***Rezoning (with proffer) #2022-00007  
Development Site Plan #2022-00004  
Subdivision #2022-00004  
Edgewood Towns***

<b>Purpose of Application</b>
The applicant requests approval of a Rezoning with proffer, Development Site Plan with modifications, and a Subdivision to create seven (7) lots of record with townhomes and associated site, streetscape, and landscape improvements.
<b>Applications, Special Use Permits, and Modifications Requested:</b>
<ol style="list-style-type: none"> <li>1. Rezoning from the RB/Townhouse zone to RC/High Density Apartment zone, with proffer;</li> <li>2. Development Site Plan with modifications to construct seven (7) townhomes and site improvements, including: <ol style="list-style-type: none"> <li>a. shared driveway and parking access pursuant to Zoning Ordinance Section 7-1600(F);</li> <li>b. reduced size parking spaces pursuant to Zoning Ordinance Section 11-512(B);</li> <li>c. modifications to setbacks pursuant to Zoning Ordinance Section 11-416; and</li> </ol> </li> <li>3. Subdivision to subdivide the existing one (1) lot into seven (7) lots.</li> </ol>

**Staff Recommendation: APPROVAL WITH CONDITIONS**

Figure 2: Landscape Plan

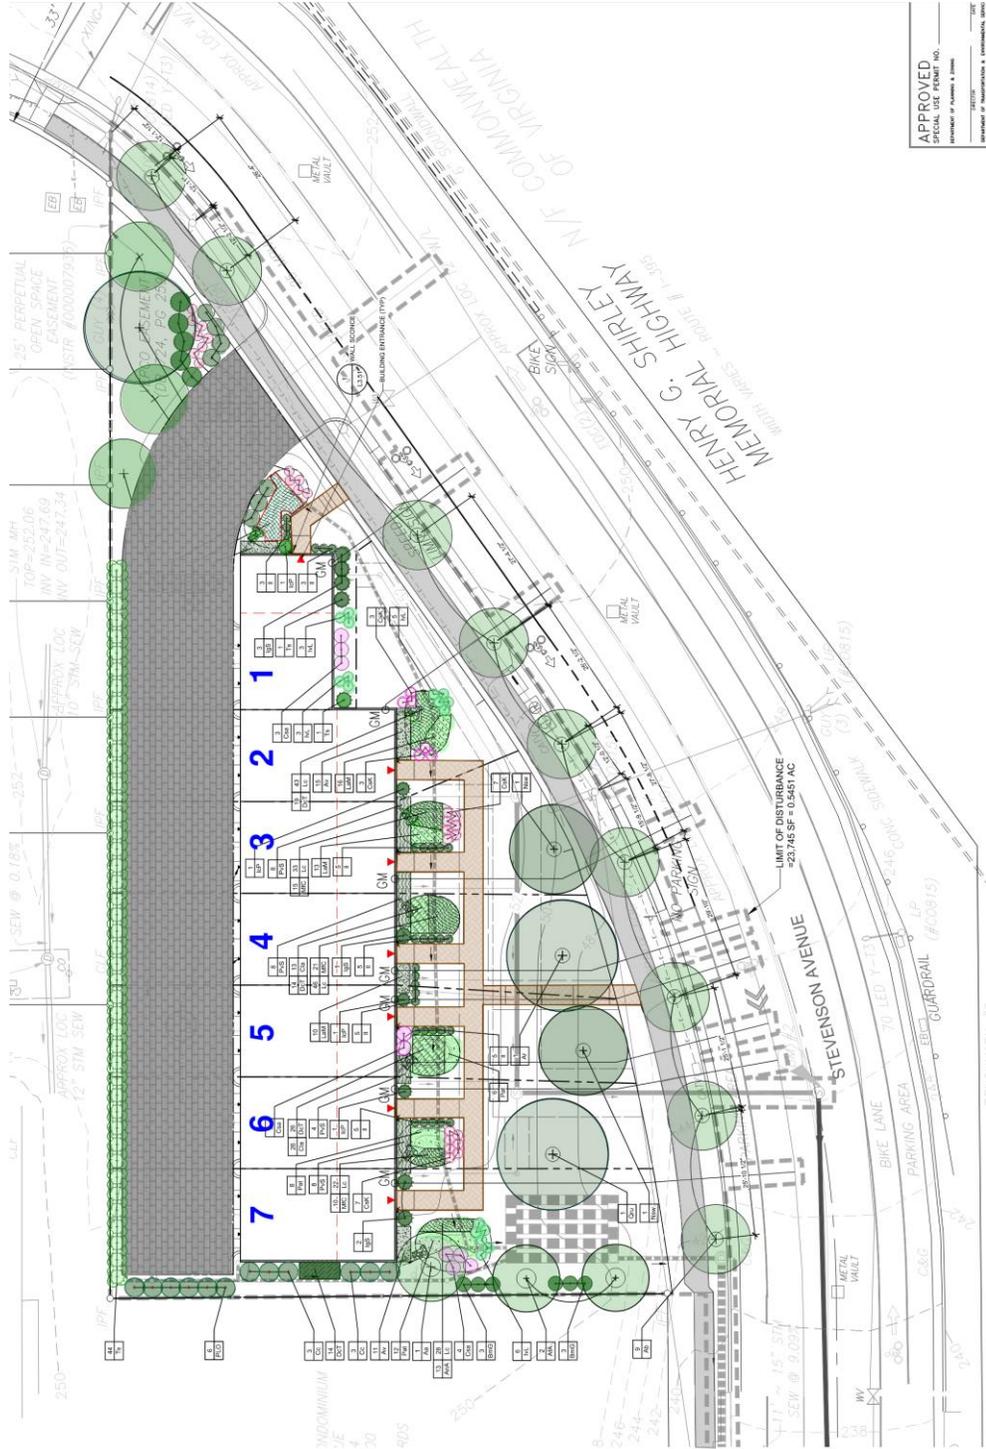
The landscape plan responds to the site shape, layout, context, and topography. All plants and trees on private property will be maintained by a homeowner’s association. Trees are planted in front yards to enhance the curb appeal of the project to the greatest extent possible, and bio-retention areas feature plantings that perform stormwater management on the site while being aesthetically integrated with the overall plan.

Staff finds that the plan satisfies the design intent to provide “enhanced landscape areas on the lot” as mitigation for the placement of the private driveway across the required rear yards, as previously described in this report. Perimeter plantings along the rear and sides of the site were improved per staff requests. The Applicant adjusted underground stormwater infrastructure in the front yards so that additional trees and plantings could be placed along the eastern site edge, and an open area west of the entry driveway will have dense plantings to provide a focal point.
